PENRHOS, CAE GLAS & KINGSLAND, HOLYHEAD

APPLICATION NUMBER 46C427K/TR/EIA/ECON

Responses to Impact on Woodland assessment received from Ed Henderson
on 14/02/2013 - PLANIT RESPONSE

Figure 1
Excerpt from Illustrative Masterplan
PL1114.P.GA100 revJ

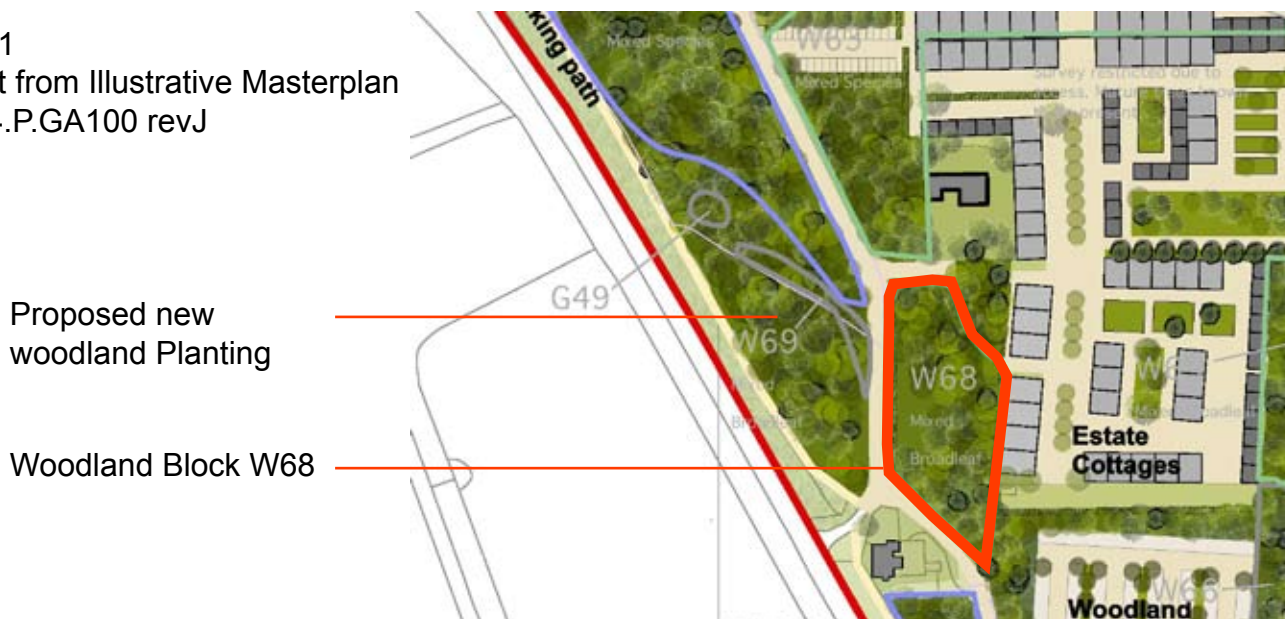
Comment: An area of lodges is shown on the indicative layout for the eastern area of W68. This would result in fragmentation if the wooded area if existing trees were retained, and should be avoided to the extent noted in the tree report.

Response: To reduce the impacts on this woodland block from the new leisure village, the parking within this area has been removed and the footprint of development reduced - please refer to figure 1 below which shows the Illustrative Masterplan layout for this area. The whole of W68 is now shown as retained which ensures that the important buffer to the A55 is maintained. Additional proposed planting along this boundary will reinforce this woodland block.
